# CITY PLANNING COMMISSION

APPLICATION: Special Permit to develop 54 townhouse units in the Light Density Multiple Family-Review (R-3-R) zone (Section 7-C)

LOCATION: 2360-2400 Northview Drive

PROPOSAL: The applicant is requesting the necessary entitlements to develop 54 townhouse condominium units.

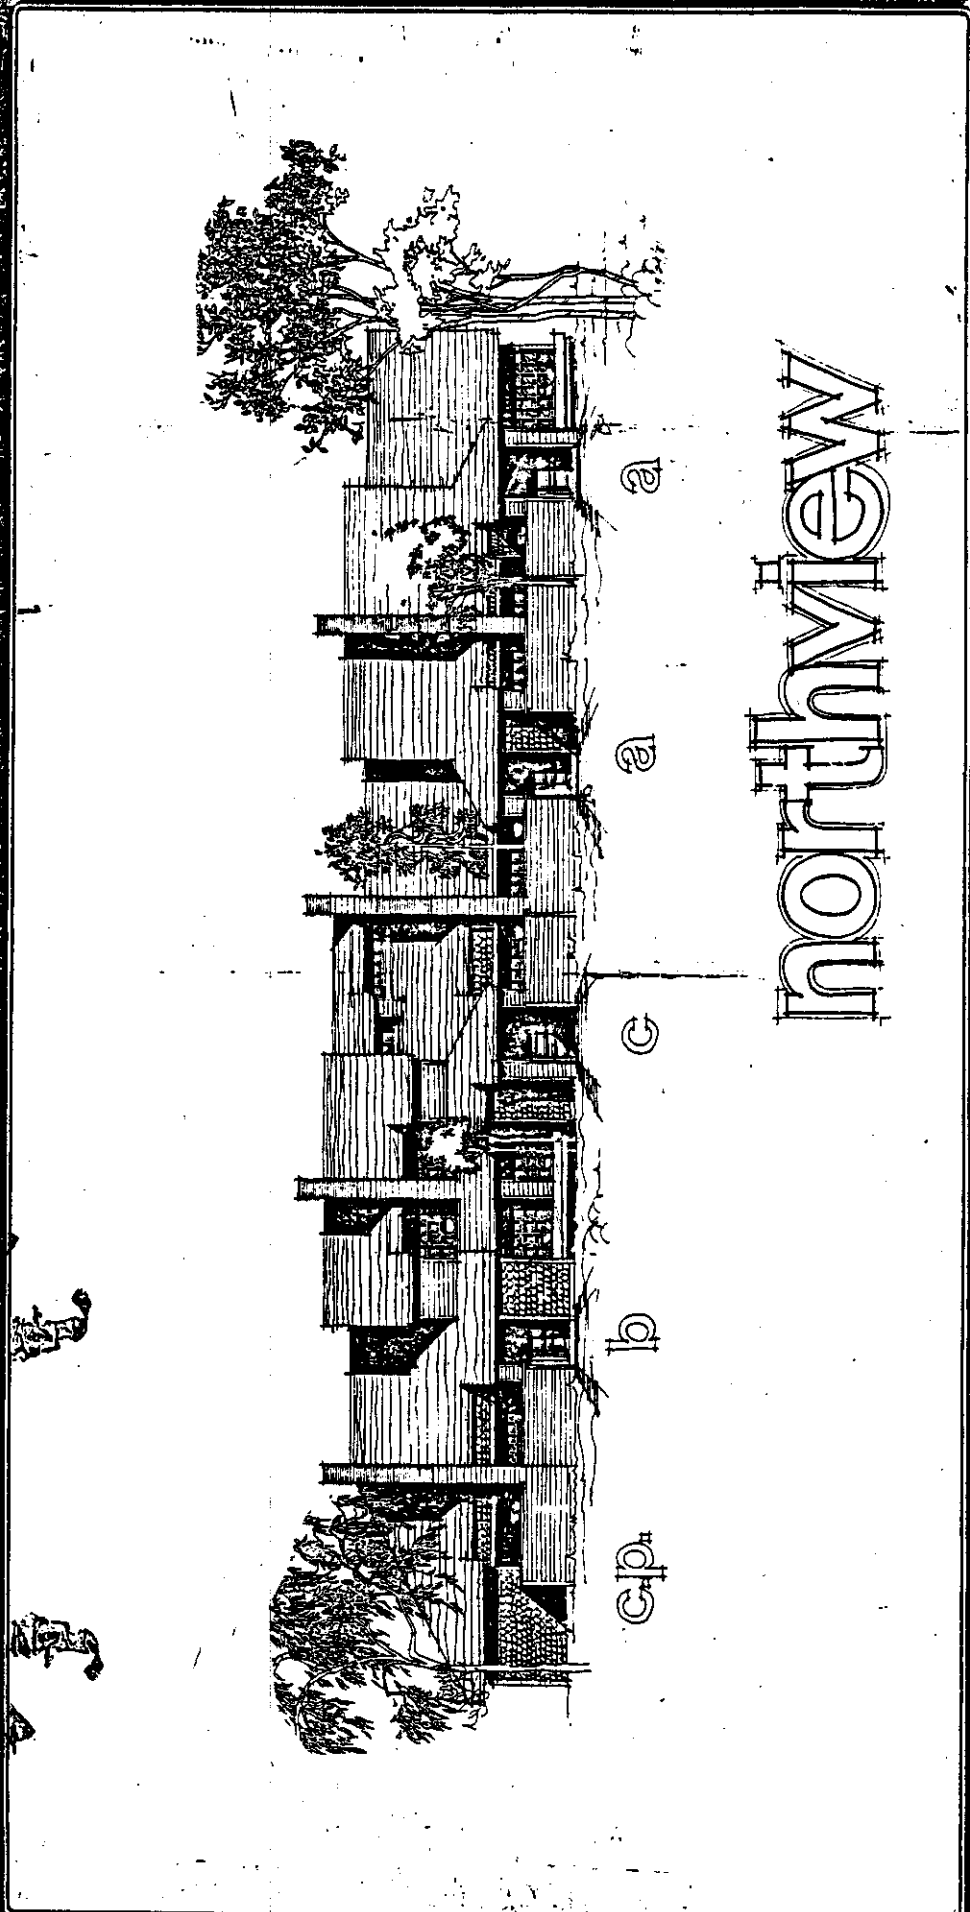
2. On-site parking appears to be covered for residents in the conceptual site plan. This conforms to the design criteria established for multiple family residential development. The covered parking will also provide adequate parking lot shading.

3. The applicant has not submitted detailed landscape plans, however, the site plan indicates very limited available planter area along the property boundary lines. As originally approved, the special permit was conditioned to require additional landscaping around the perimeter of the site to provide a buffer between the adjacent single family development and commercial uses. Staff further recommends the applicant provide undulating landscaped berms in the front setback and not allow walkways to discourage parking on the public street. The landscape strip along the northerly site boundaries should be a minimum of 10 feet wide and be landscaped with dense trees and groundcover. The applicant should use the landscape guidelines outlined in the Multiple Family Residential Design Criteria in developing a landscape plan for this site (see exhibit D).

4. The special permit was originally conditioned to require that the proposed driveway entrances be changed to address concerns expressed by the City Traffic Engineer. The Engineer indicated the following modifications would be necessary: a) the north driveway should be a 90° angle and b) the south driveway shall be a minimum of 24 feet wide and 10 feet away from the south property line (see exhibit A).

5. As proposed, the site plan indicates that five parking spaces are to be located in the 25' front landscaped setback area. In addition, the applicant has used parallel parking on the site. These spaces shall be removed and replaced with landscaping since they do not comply with the Zoning Ordinance (Section 6-C-1(a) and Section 6-D-13).

8. The site plan did not indicate the location and type of trash enclosures to be used for this project. Staff recommends the applicant submit detailed plans for the enclosures, using the guidelines in exhibit D.
9. The subject site is surrounded on two sides by commercial zoning and the north side of the site is developed with single family uses. Staff recommends the applicant provide a six foot decorative masonry wall around the perimeter of the site to help buffer the varied uses from one another as set forth in the attached Multiple Family Residential Guidelines.

1. The applicant shall submit a detailed landscape shading and irrigation plan to the Planning Director for review and approval prior to issuance of building permits. The plans shall comply with the landscape design criteria indicated in exhibit D. The plans shall also include undulating berms in the front setback area.

2. The applicant shall redesign the driveway entrances to the satisfaction of the City Traffic Engineer.
3. All parallel parking spaces and those spaces located within the 25' front setback area shall be removed and replaced with landscaping.

8. A 10 foot landscape setback shall be provided along the northerly property line adjacent to the residential dwellings.
